RESPONSE TO REQUEST FOR ADDITIONAL INFORMATION

APR1400 Design Certification

Docket No. 52-046

RAI No.: 314-8378
SRP Section: 10.03.06 – Steam and Feedwater System Materials
Application Section: 10.3.6
Date of RAI Issue: 11/16/2015

Figure 1. Wear rate trend by system of KSNPs

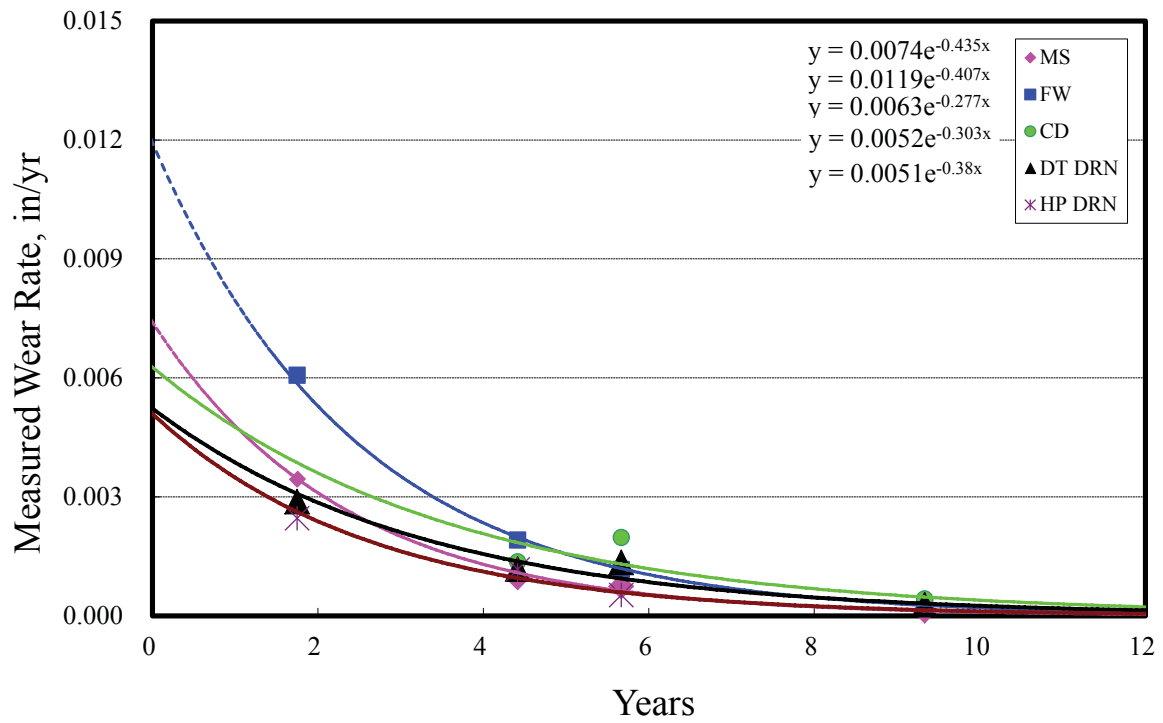
The NRC staff seeks information on the FAC program that is “generally based on NSAC-202L-R3” and FAC measurements on Korean standard nuclear power plants.

- Describe the Korea Hydro and Nuclear Power (KHNP) FAC program and how the procedure deviates from NSAC-202L.
- How are the actual measurement records from the standard nuclear power plants representative and bounding of the APR1400 design?
- What are the differences in coolant conditions between the APR1400 and the “Korean standard design plants” in terms of material specifications, steam/feedwater flow, water chemistry, and temperatures? If there are differences in the coolant conditions for the APR1400 as built condition compared to the existing Korean standard design plants,

discuss the impact of the different coolant conditions on the erosion rate described above in FSAR Section 10.3.6.3 a.

The wear for 5 systems of 4 units typed of KSNP was determined based on UT data of the components inspected over twice during past 10 years. The number of used components by system is 53 of CD, 98 of FW, 37 of MS, 43 of Drain Tank of RHDT & MSDT (DT DRN), and 30 of HP HTRs Drain (HP DRN) systems.

The PTP (Point-to-Point) method for UT analysis (UTA) was applied based on the available UT data. As shown in the Figure 1, the wear trends by system were developed based on the Curve Fitting method by operating year and assumed the wear after 9.33 years is same.

Here, the affecting parameters to FAC are flow velocity and temperature, and pH. As described in Table 1, the temperature and pH are similar between OPR1000 and APR1400. So, the corrosion allowances determined in KSNP was used in APR1400.
